CONNECTORIZED EXCHANGE CABLE SPLICING (CONECS) SYSTEM

1.001 This addendum supplements Section 626-500-101, Issue 2. Place this pink sheet ahead of Page 1 of the section.

Fig. 28—Template Use (Sheet 1)

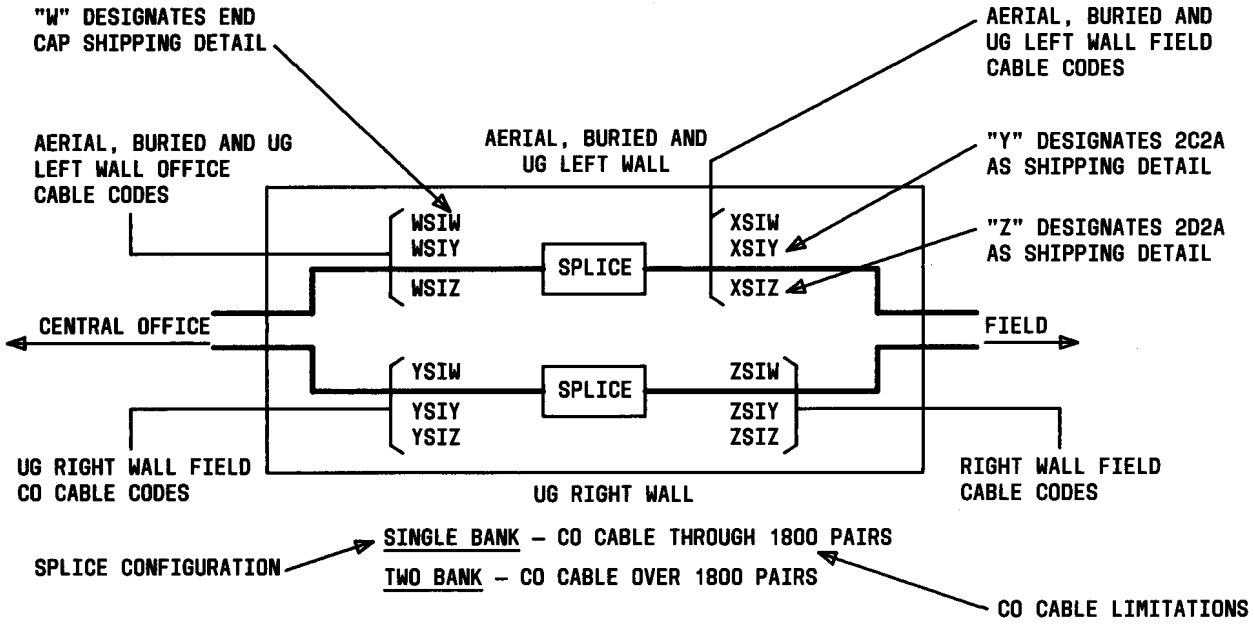
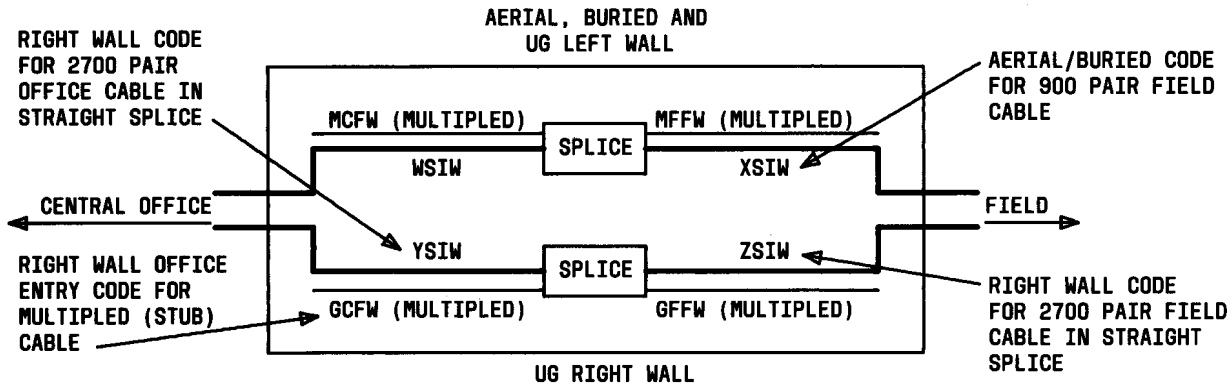
(c) To change code designations on Fig. 28, "Template Use", Page 73

2.003 On Page 73 of the section, change the code designations on Fig. 28 to the code designations shown in the revised Fig. 28.

Fig. 41-2—Valid PC-12/55 PEDESTAL SPLICE Codes

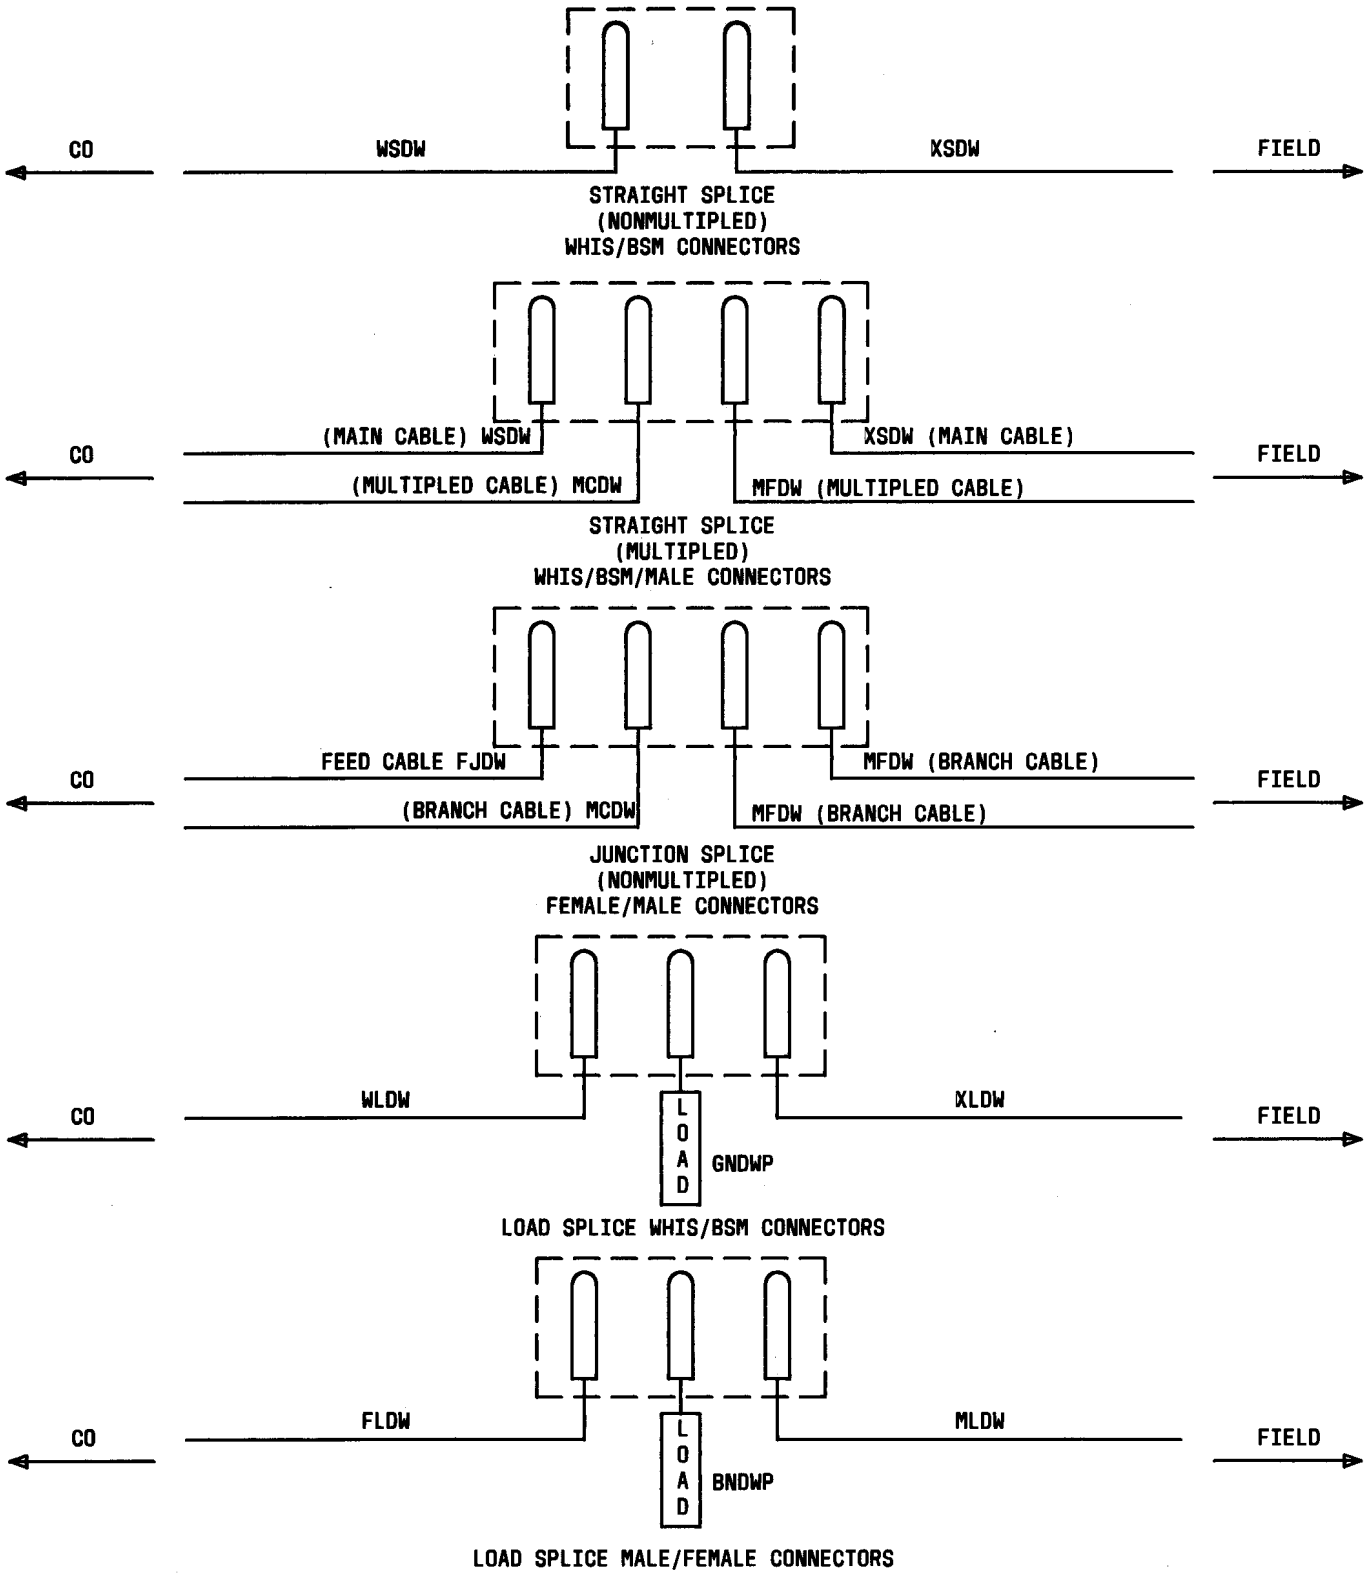
(f) To add Fig. 41-2, "Valid PC-12/55 PEDESTAL SPLICE Codes", Page 89-2

2.006 Add Page 89-2 to show Fig. 41-2 "Valid PC-12/55 PEDESTAL SPLICE Codes."

Fig. 41-3—Valid UP-1248 PEDESTAL SPLICE Codes

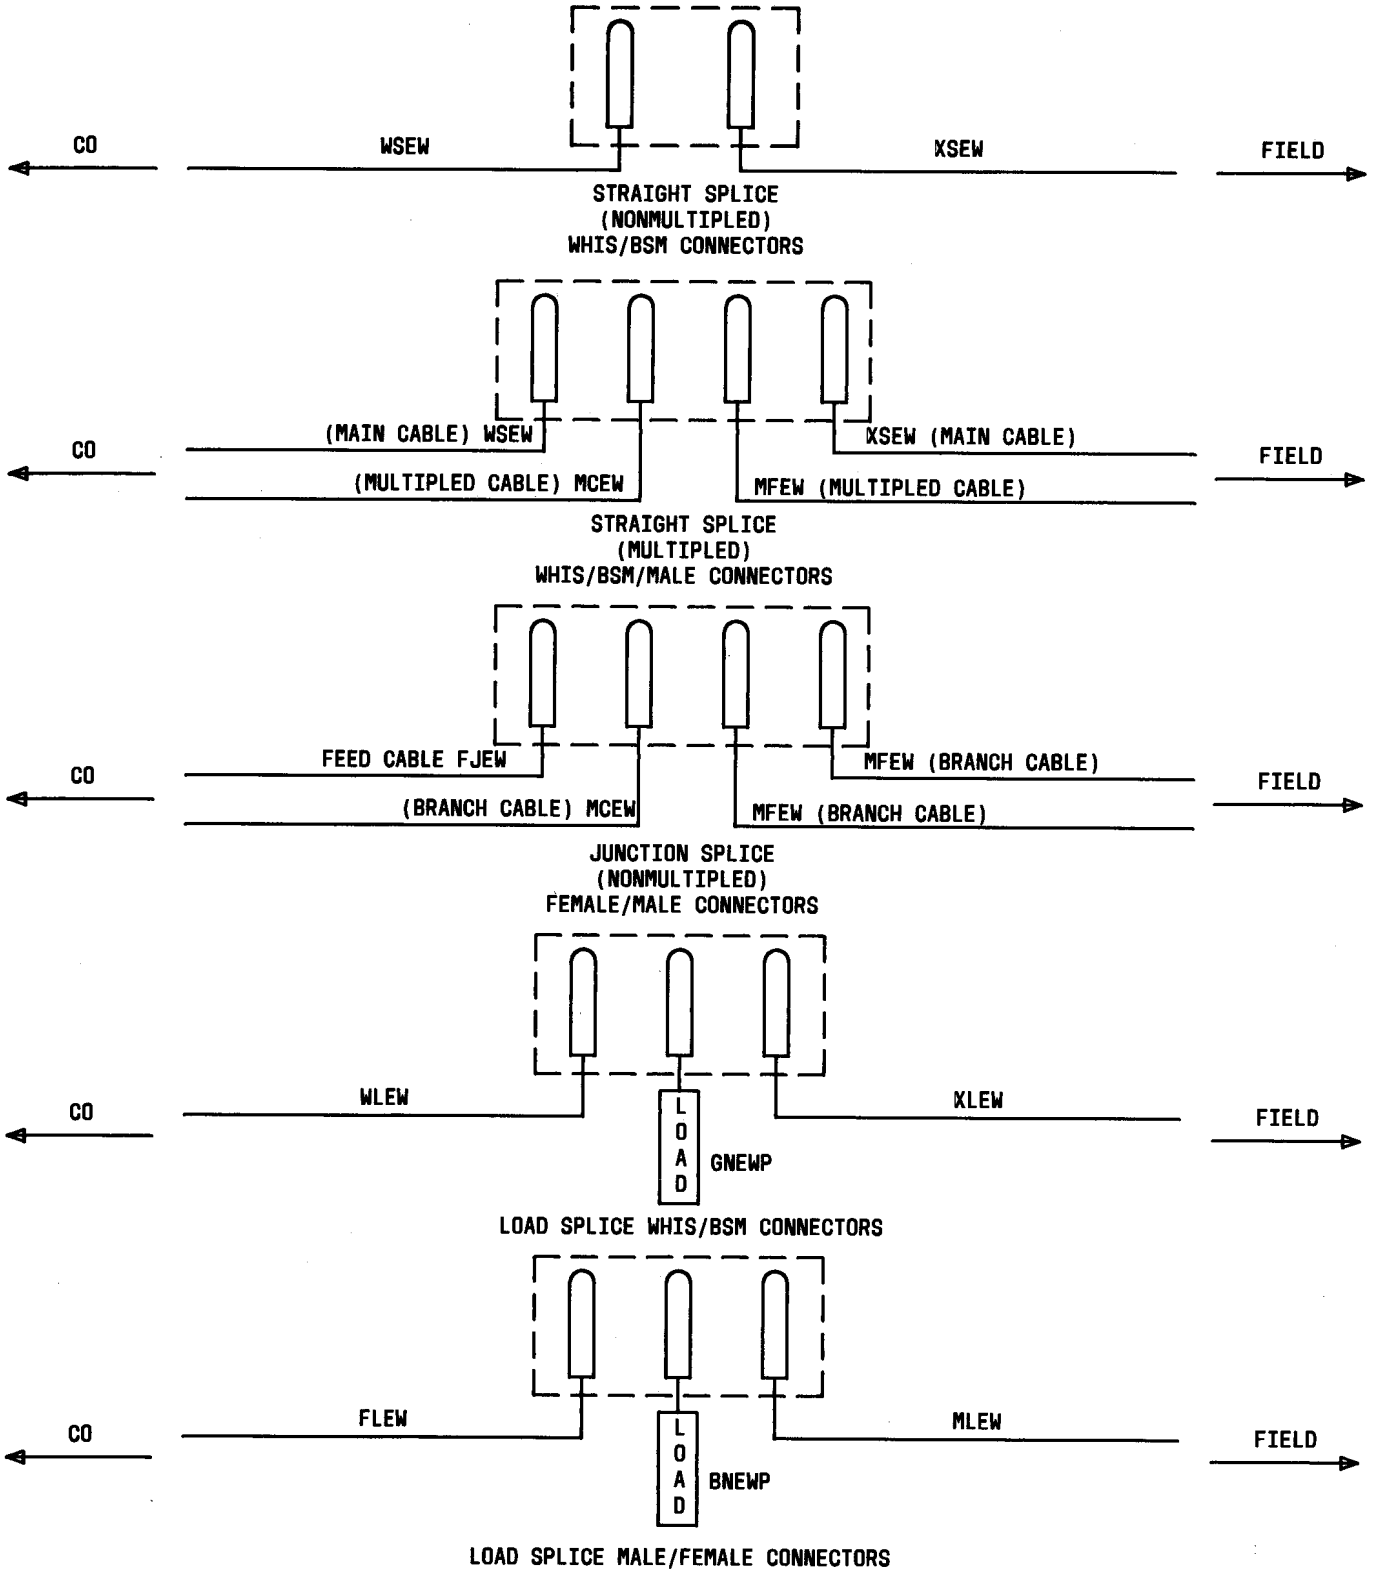
(g) To add Fig. 41-3, "Valid UP-1248 PEDESTAL SPLICE Codes", Page 89-3.

2.007 Add Page 89-3 to show Fig. 41-3 "Valid UP-1248 PEDESTAL SPLICE Codes".
